La Marzocco Technical Bulletin # 132

Vulcano Swift new power board.

March 15, 2017

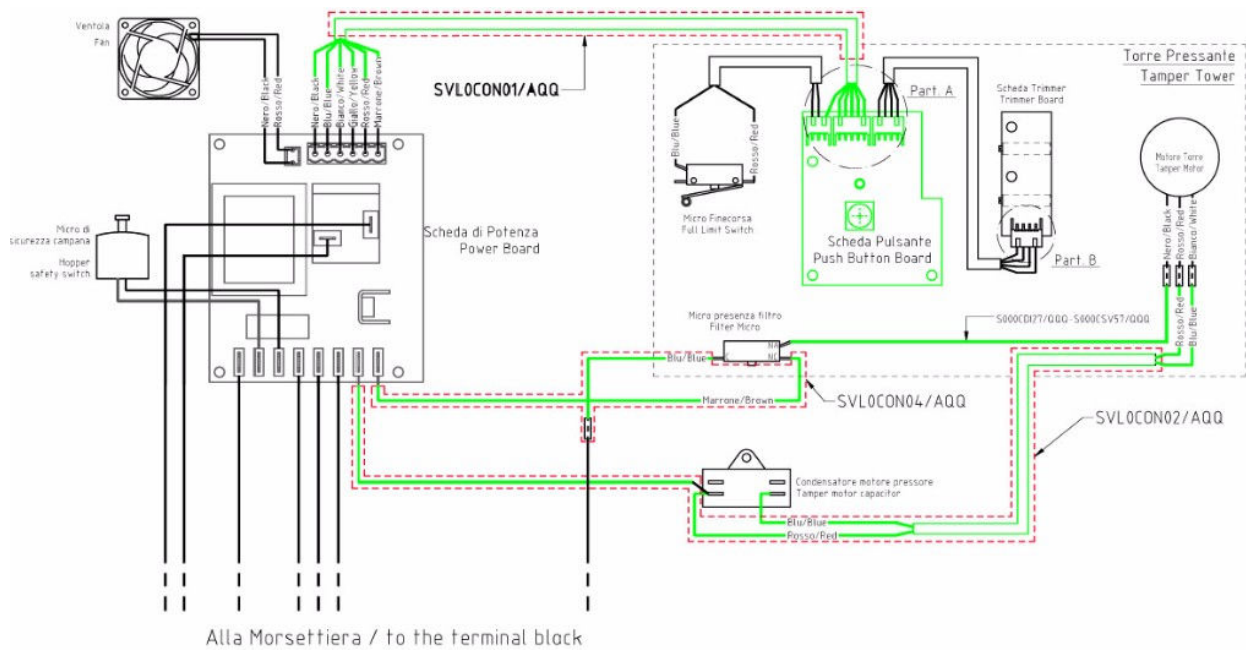
The Vulcano Swift power board has been modified and now has different connections. Only the new version of the power board is available as a replacement part. In the event the power board needs to be replaced it will be necessary to pay attention to the serial number to confirm if a retrofit kit is necessary.

All Vulcano Swift starting from serial number 1349118 have the new board. The retrofit kit is not necessary. If the serial number is 1349117 or lower, the retrofit kit is required.

The retrofit kit includes a new power board, new push-button board and all necessary cables. Everything in green in the following diagram is included in the retrofit kit and will need to be replaced:

The green components must be replaced

M.1.039 Vulcano Retrofit board kit, 120V (SN up to 1349117)

M.1.291 Vulcano, Swift Power Board
